# **CNWRA** *A center of excellence in earth sciences and engineering*

Subject: Submittal of report "Effect of In-Package Chemistry on the Degradation of Vitrified High-Level Radioactive Waste and Spent Nuclear Fuel Cladding" (CNWRA 2002-01), Intermediate Milestone 01402.571.180

## RESPONSES TO NRC COMMENTS ON IM 01402.571.180

### **"EFFECT OF IN-PACKAGE CHEMISTRY ON THE DEGRADATION OF VITRIFIED HIGH-LEVEL RADIOACTIVE WASTE AND SPENT NUCLEAR FUEL CLADDING"**

Figure 2-5. Normalized Leach Rate for Boron Versus Time for WVDP Ref. 6 and DWPF Blend 1 Glasses in Various Solutions at 90 °C

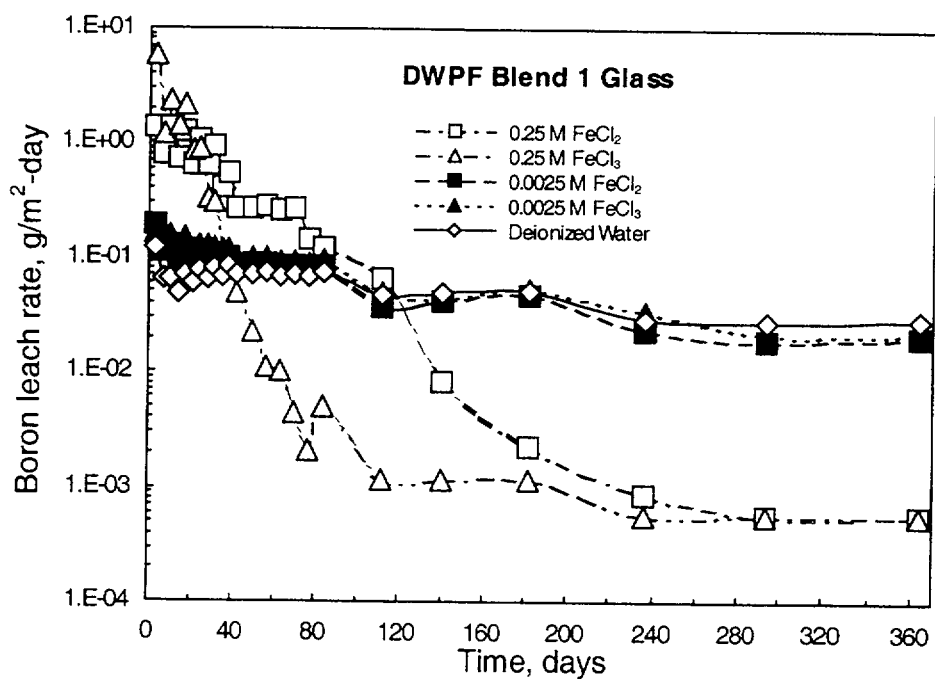
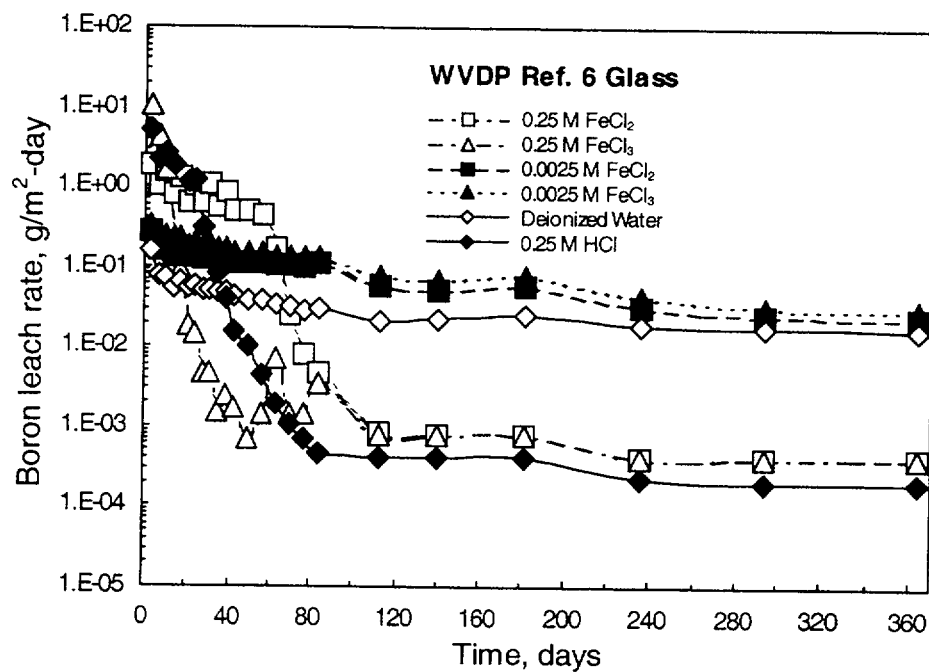
13. **Page 23, 3<sup>rd</sup> paragraph. "This theory is supported by....in Figure 2-5." Could not find the inductively coupled plasma atomic emission spectrometry analyses results in the figures.**

The boron leach rates plotted in Figure 2-5 are from the inductively coupled plasma atomic emission spectrometry analyses. No change made.

Figure 2-6. Normalized Leach Rates for Various Elements as a Function of Time for WVDP Ref. 6 Glass in 0.25 M FeCl<sub>3</sub> Solution at 90 °C

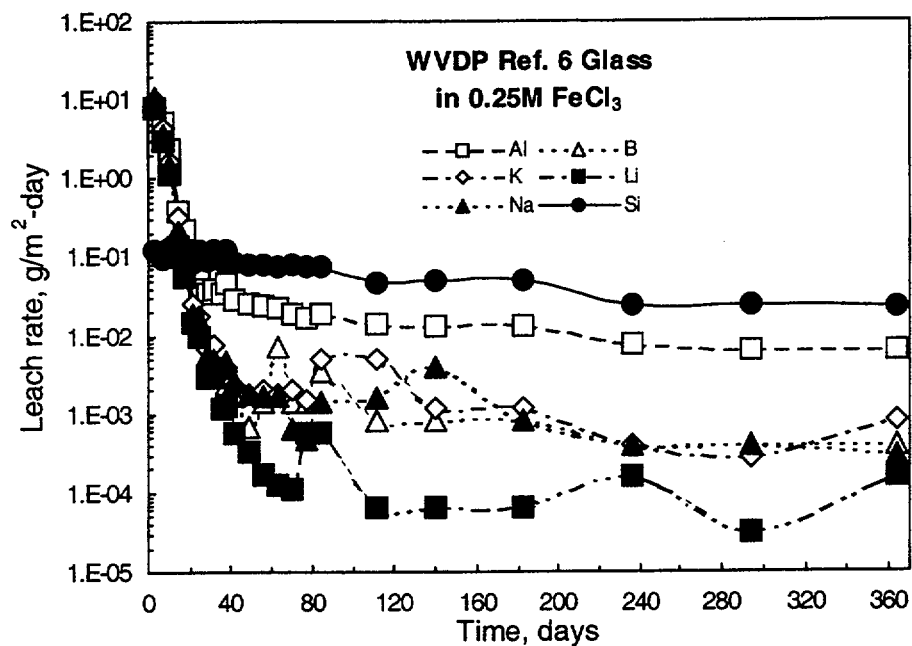
14. **Page 23, 3<sup>rd</sup> paragraph. "In the case of glass dissolution...(Figures 2-5 and 2-7)." Is the paper referring to Figure 2-6 instead of 2-5?**

Figure 2-7. Leachate pH Versus Time for WVDP Ref. 6 Glass in Various Solutions at 90 °C (Closed Symbols for the Initial pH and Open Symbols for the Final pH)

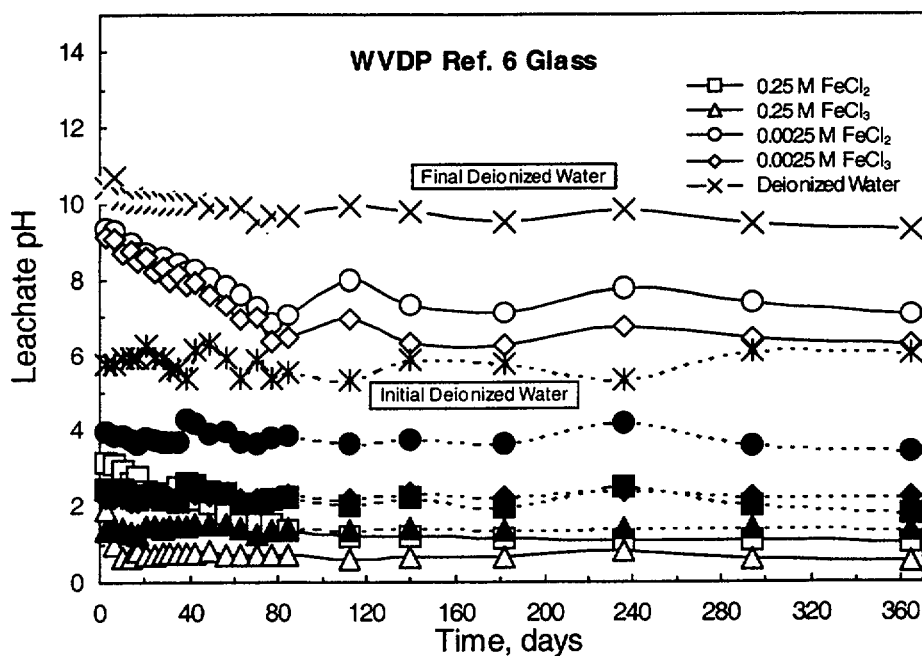
12. **Page 18, 3<sup>rd</sup> paragraph. "In all cases, except the leachates..." In figure 2-7, it appears (this is a copy and I don't have the data set) that the final pH levels are lower than the initial pH levels.**

From the glass leaching tests, the final pH values of the solutions are generally higher than the initial pH except the high concentration iron chloride solution tests. Text modified.
